Planning and Land Use Committee Report For the Meeting of July 23

Subject: Development Permit with Variances No. 000377 for 613 Herald Street

The purpose of this report is to present Council with information, analysis and recommendations for a Development Permit Application for the property located at 613 Herald Street. The proposal is to construct a five-storey, mixed-use building with ground-floor retail fronting Herald Street and residential uses above.

1 Front Streetscape Elevation (North)

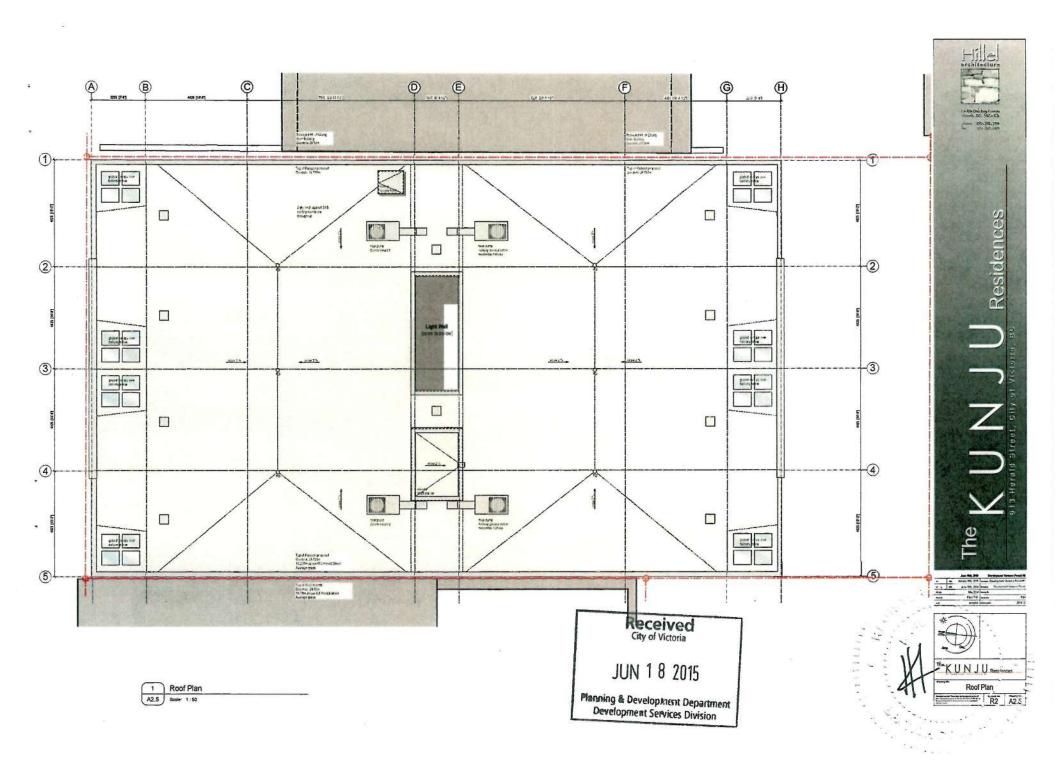
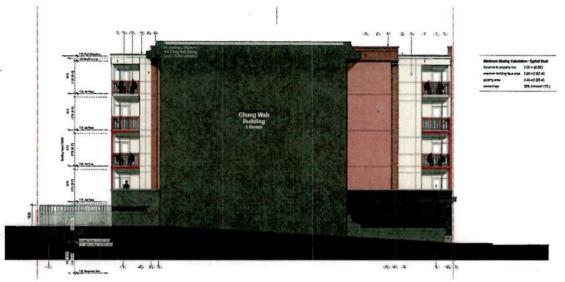
- In fact, the March 2015 proposal (unchanged in the current version) is significantly worse than the August 2014 version as the cladding material has been downgraded from panelized float finish acrylic stucco to painted concrete block on the building sides and Fibre Cement Board on the front and rear facades. These material substitutions make up most of the exposed surface area of the building with large areas of exposed concrete block facing neighbouring residential units to the west and a large area clearly visible from the street to the east. The LUC's position on the use of such materials in "Old Town" is well known. They are simply not acceptable.

- The Brick lintel feature has been moved up an additional storey however it remains a sparse application of the only desirable cladding material proposed.

- The "green wall" adjacent to 601 Herald promised in the D'Ambrosio design has not been included in the Hillel version but if utilized might compensate for the exposed concrete block.

The DRA cannot support this proposal unless the cladding materials are upgraded at least to the level of August 2014. It would help to mitigate the concrete block surfaces with an appropriate green wall. While we generally support increasing residential units in the Chinatown district, as it stands, this project is not appropriate for this important heritage area. We hope that this proposal is turned down.
